REPORT NO: SY-139R-77  
AIRTASK NO: A5345341/0532/7534000001  
WORK UNIT NO: A53411-20  
DATE: 13 July 1977

COPY NO. 45 **NAVAL AIR TEST CENTER**  
**REPORT OF TEST RESULTS**

Test and Evaluation of AH-1T Forward Ground Handling Gear Assembly (P/N 209-052-244-1);  
Second Report (Final)

Figure 1  
Forward Ground Handling Gear Assembly (P/N 209-052-244-1)

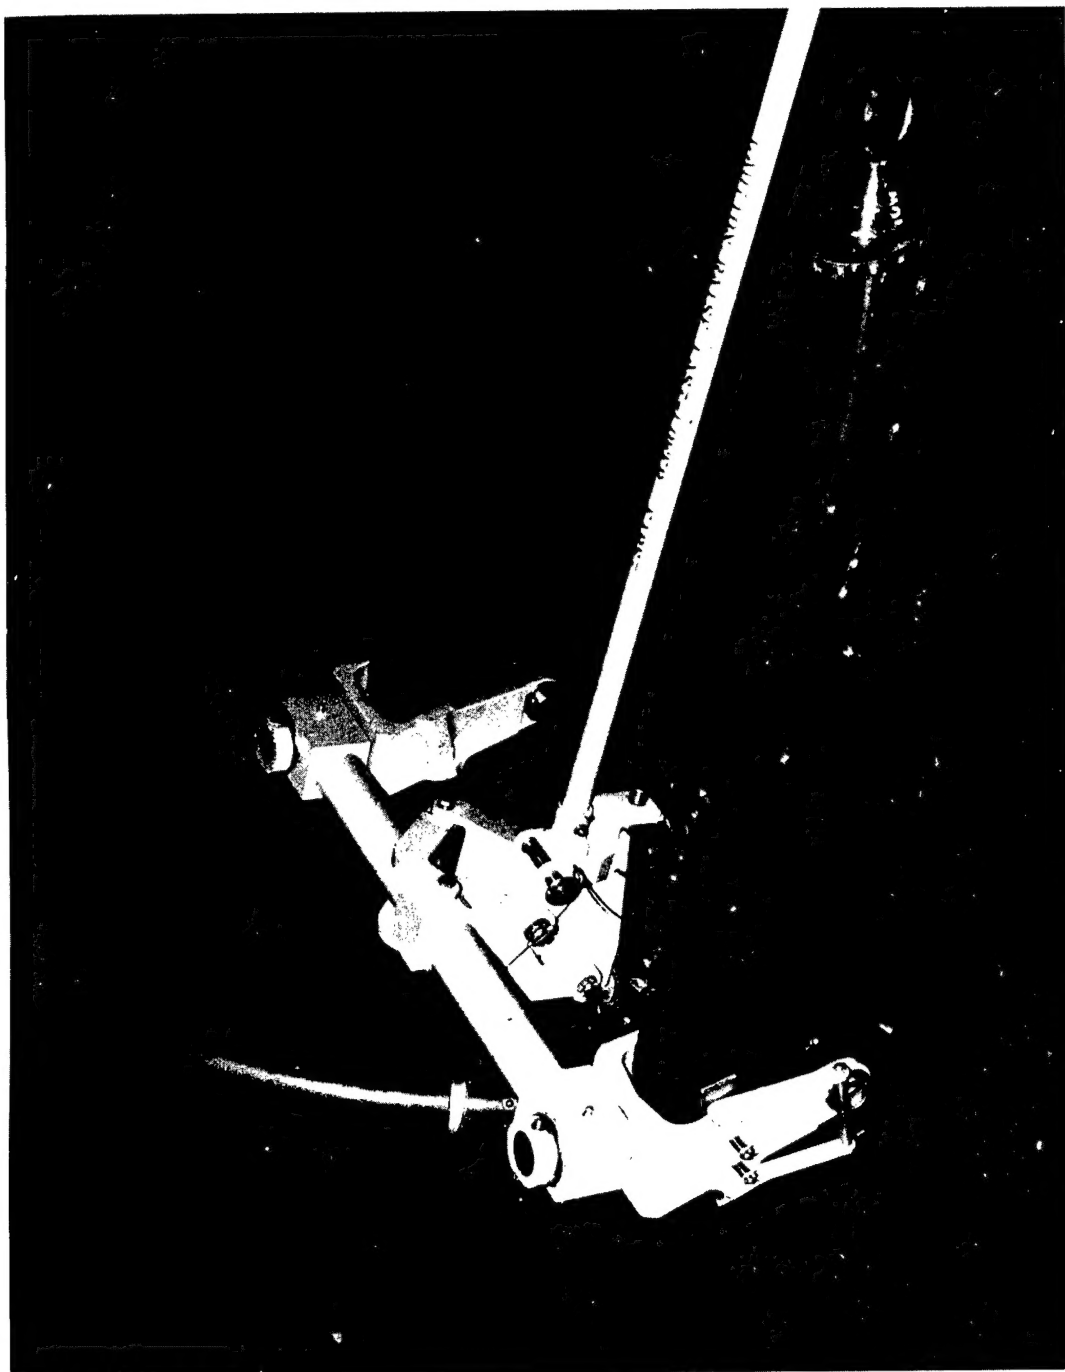
3. The Forward Ground Handling Gear Assembly (enclosure (1), figure 1) consists of two full castoring wheels connected by a common trunnion with a lift mechanism and a 36 in. (91.4 cm) lever handle. The Gear Assembly is attached to two lugs on the forward portion of each skid by means of a solid pin which engages the rear lug and a quick release pin that engages the front lug in the aircraft skid. The lever handle must be held straight up in a vertical position while installing the Gear Assembly, then rotated forward and down to the horizontal position to raise the front portion of the aircraft skid.

4. An excessive force is required on the lever handle to raise the forward portion of the aircraft skid clear of the deck. A force of approximately 125 lb (556 N) is required at the end of the lever handle to raise the forward portion of the skid with the rear of the skid already in the raised position and the aircraft gross weight at approximately 14,200 lb (6 441 kg). A force of approximately 145 lb (645 N) is required at the end of the lever handle to raise the forward portion of the skid with the rear of the skid remaining on the deck and the aircraft gross weight at approximately 13,200 lb (5 987 kg). The excessive forces required to actuate the Gear Assembly coupled with an almost instantaneous change in force requirements as a function of rear skid position presents a potential safety hazard to maintenance personnel. In the event the forward Gear Assembly is in transition from lowered to raised or vice versa while the rear of the skid is being lowered, it is likely that the lever handle will become uncontrollable causing personnel injury and/or damage to the aircraft. The excessive force requirements on the lever handle is a Part I deficiency which must be corrected as soon as possible.

21. Correct the Part I deficiencies cited in paragraphs 13 through 16 as soon as possible.

Figure 2  
Brake Assembly

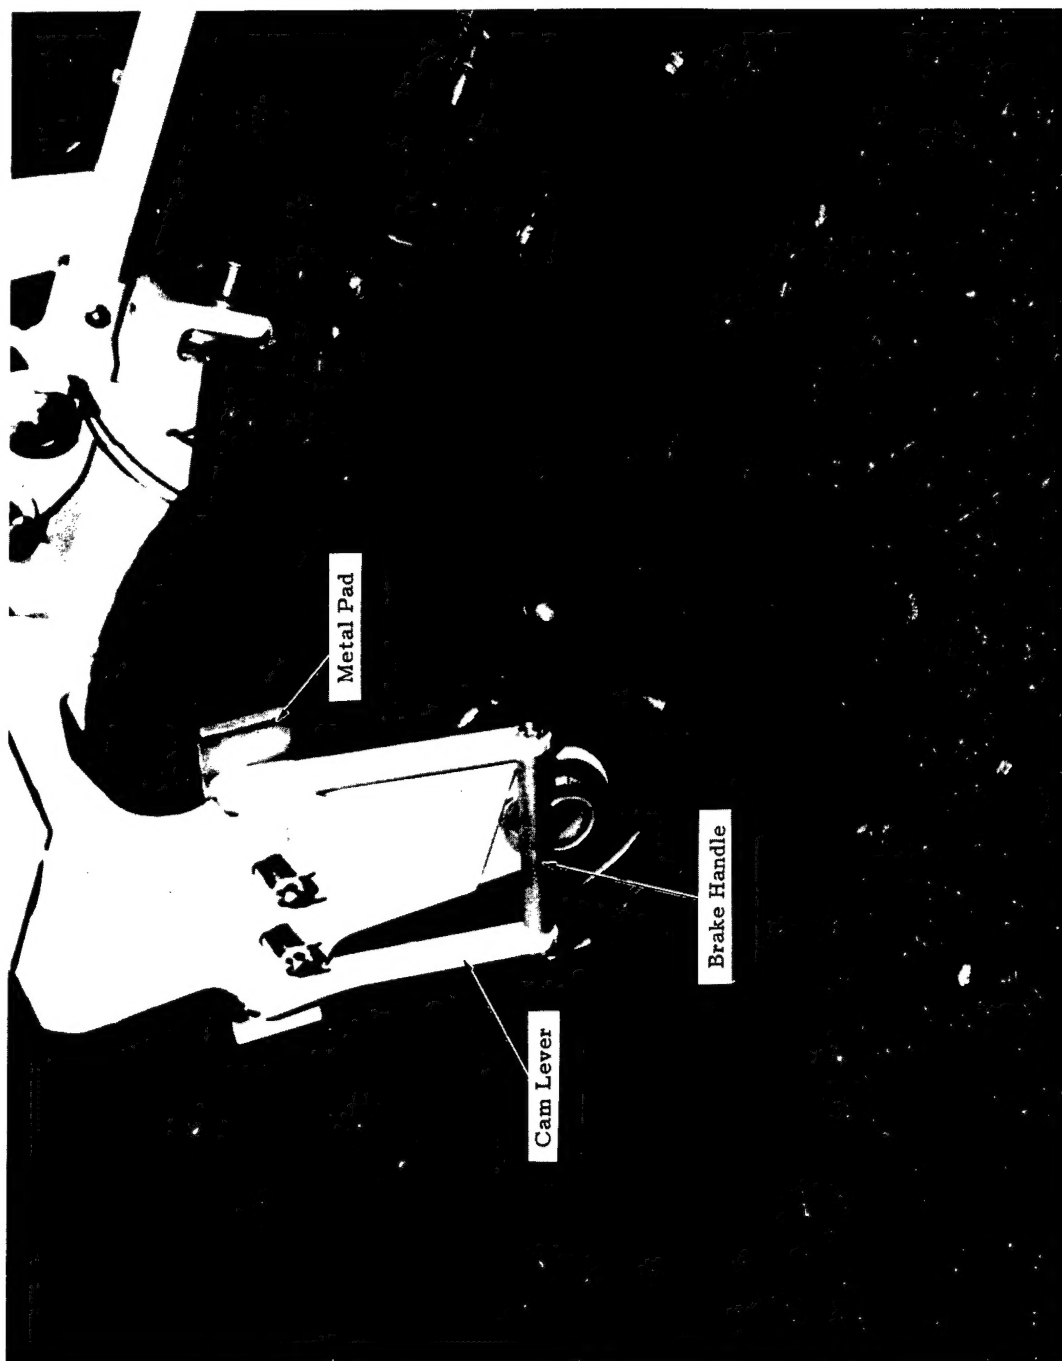
5. The means of stopping tire rotation are inadequate. The brake assembly consists of a cam-lever that contacts a metal pad which then presses against only one side of the pneumatic tire (enclosure (1), figure 2). Applying pressure to only one side of the tire causes tire deflection but does not prevent tire rotation. In addition, there is only one brake on each Gear Assembly which is located on the side of a caster housing. When the aircraft is being moved in one direction, the brake assembly is outboard of the tire. However, when the direction is reversed, the castored wheel rotates 180 deg placing the brake assembly on the inboard side of the tire. This type of brake assembly will result in maintenance personnel not being able to stop the aircraft in an emergency situation. The inadequate means of stopping tire rotation is a Part I deficiency which must be corrected as soon as possible.

6. There is a lack of provisions to prevent the brake assembly handle from being rotated 180 deg through the horizontal position. While the brake is off, the handle is in a vertical down position (enclosure (1), figure 2). To engage the brake, the handle must be pulled up to a horizontal position. Continuing to pull the handle up over center will place it in a vertical up position and will disengage the brake. In the up position, the handle will rest against the upper support of the wheel assembly (enclosure (1) figure 3). Maintenance personnel applying the brake and

failing to stop at the horizontal position will have their hand trapped between the brake handle and upper support of the Gear Assembly. Failure to provide a stop that will prevent the handle from being rotated through the horizontal position will result in a potential safety hazard to maintenance personnel. The lack of provisions to prevent the brake assembly handle from being rotated 180 deg through the horizontal position is a Part I deficiency which must be corrected as soon as possible.

Figure 5  
Inserting Quick Release Pin in Gear Assembly Housing

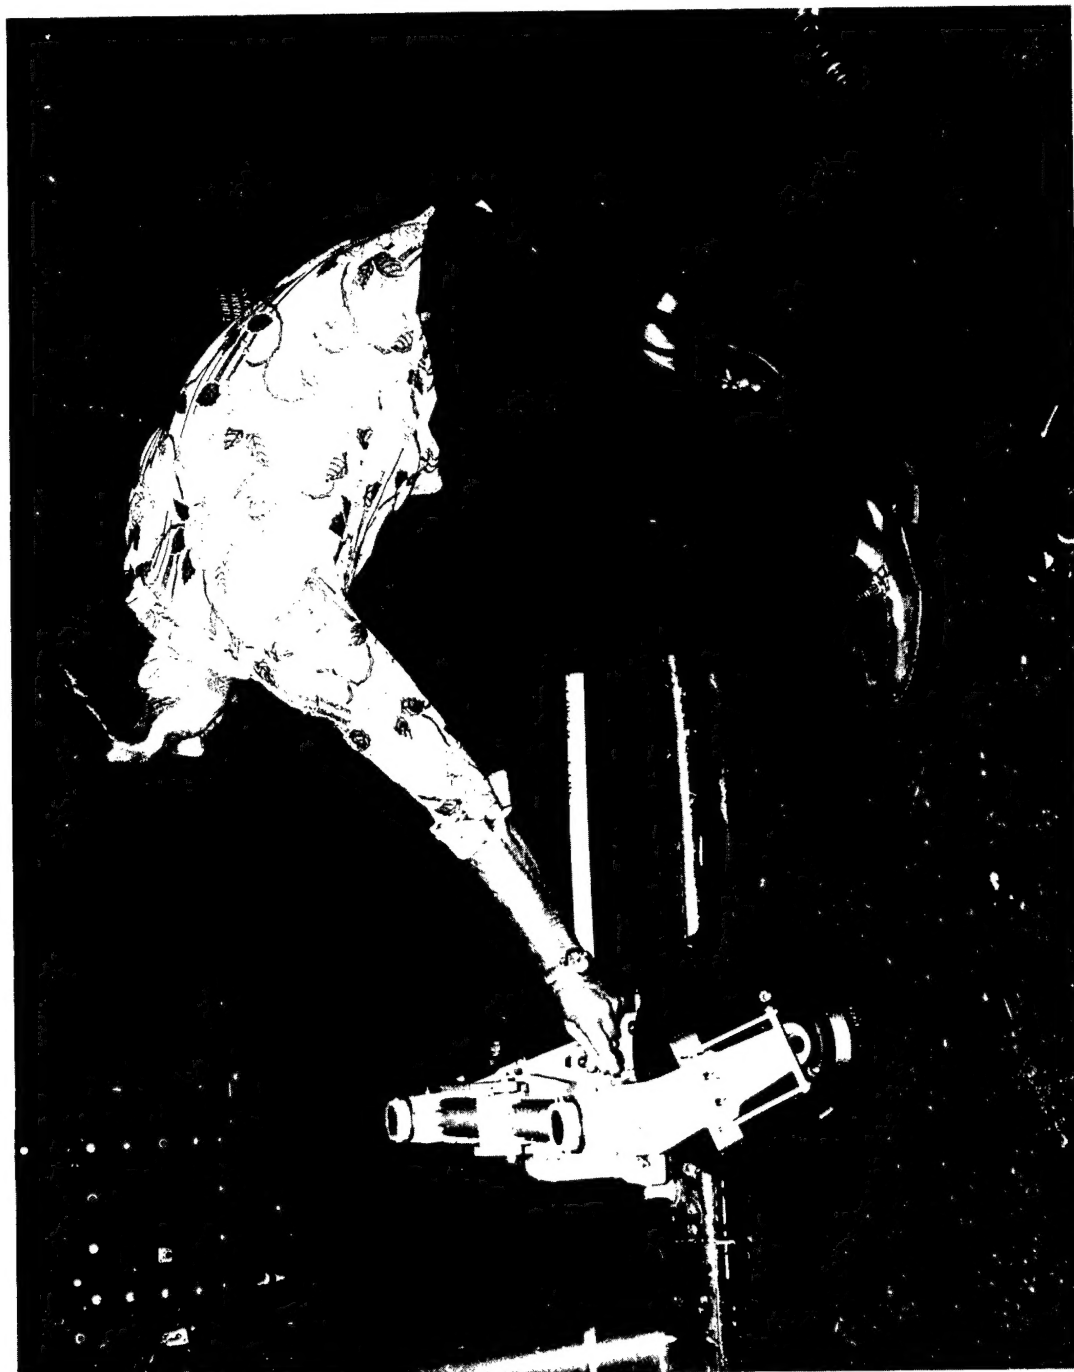
8. The shoulder bushings, in the housing where the quick release pin for securing the lever handle in the down position is inserted in the Gear Assembly, are incorrectly installed and of insufficient length. The two bushings are installed with the shoulders inboard and do not extend to the outer surface of the housings (enclosure (1), figure 6). This results in the quick release pin jamming in the housing. Also, the bushing could be pulled out of the housing by the quick release pin which would result in an abrupt raising of the lever handle and dropping of the aircraft skid. The incorrectly installed and insufficient length of the shoulder bushings constitutes a Part II deficiency which should be corrected as soon as practicable.

9. The length of the wire rope assemblies that secure the two quick release pins to the Gear Assembly is excessive. One quick release pin is used for securing the Gear Assembly to the aircraft skid front lug and the other quick release pin is used for securing the lever handle in the down position (enclosure (1), figure 6). These pins are different lengths and if interchanged will not function satisfactorily. The length of the wire rope assemblies allow either pin to be used for either application which results in a "MURPHY" situation. Also, the quick release pin could be damaged as a result of being caught under the skid while lowering the aircraft. The excessive length of the wire rope assemblies constitutes a Part II deficiency which should be corrected as soon as practicable.

22. Correct the Part II deficiencies cited in paragraphs 17 through 19 as soon as practicable.

Figure 6  
Quick Release Pin Housing

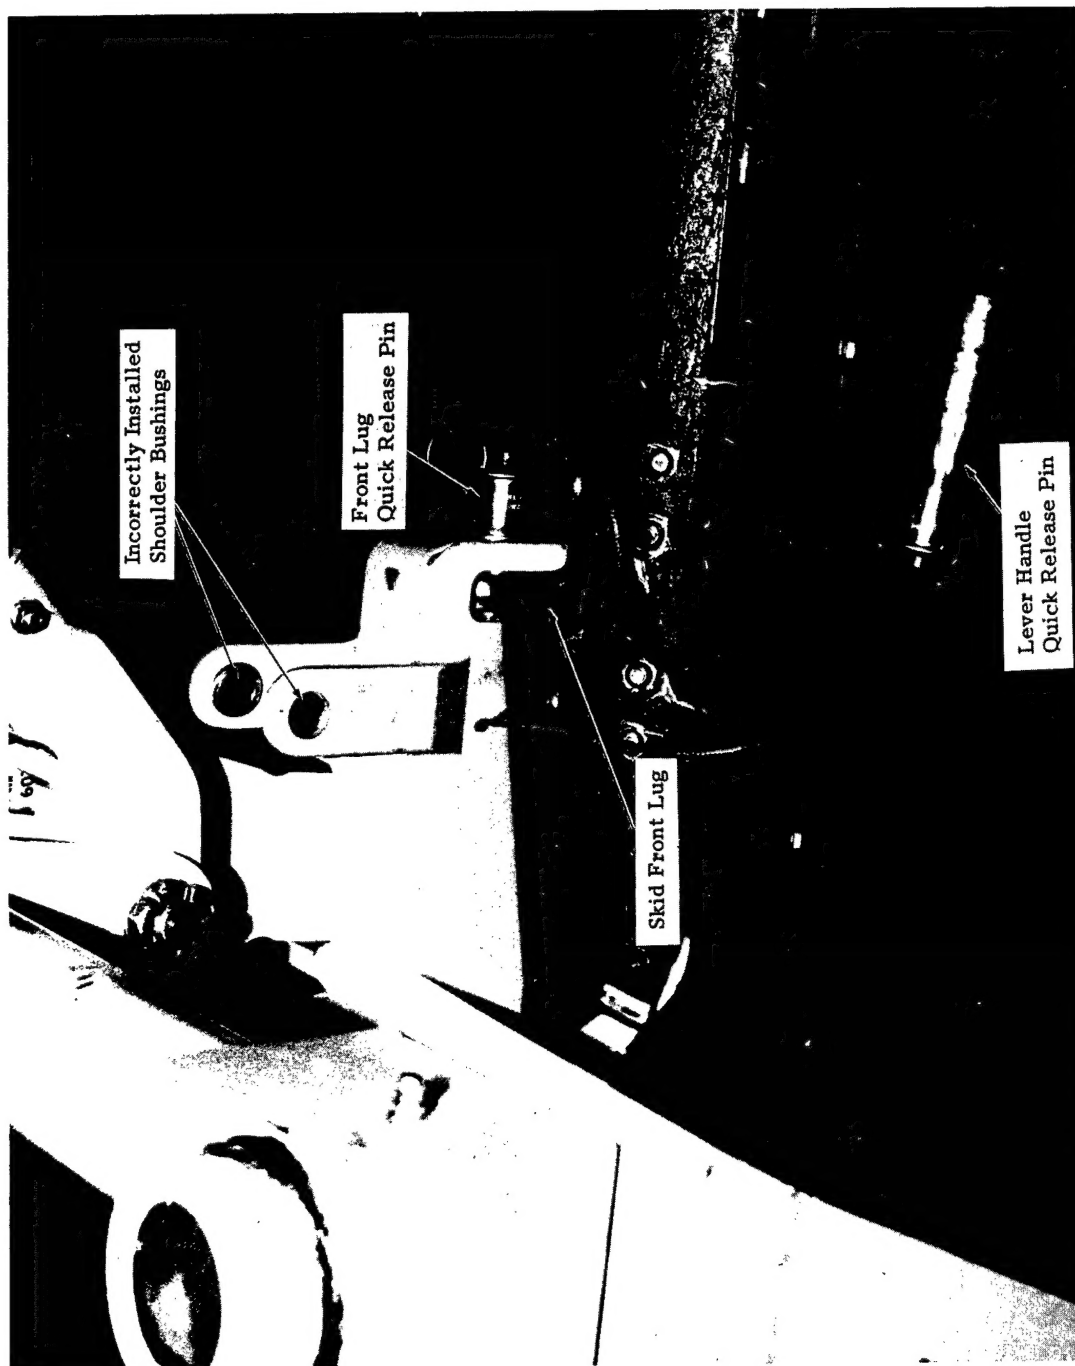
10. There is a lack of support for both ends of quick release pin. The forward attachment point for securing the Gear Assembly to the aircraft skid (enclosure (1), figure 6) consists of a bushed hole in the gear housing. A quick release pin is inserted through the bushed hole and a hole in the aircraft skid front lug. The aircraft weight is exerted on the quick release pin which is not supported at both ends and results in a bending moment being applied to the quick release pin. Failure to support the quick release pin at both ends so that a shear load is applied to the pin will cause excessive bushing wear and pin deformation which will result in the inability to secure the wheel assembly to the aircraft. The lack of support for both ends of the quick release pin is a Part II deficiency which should be corrected as soon as practicable.
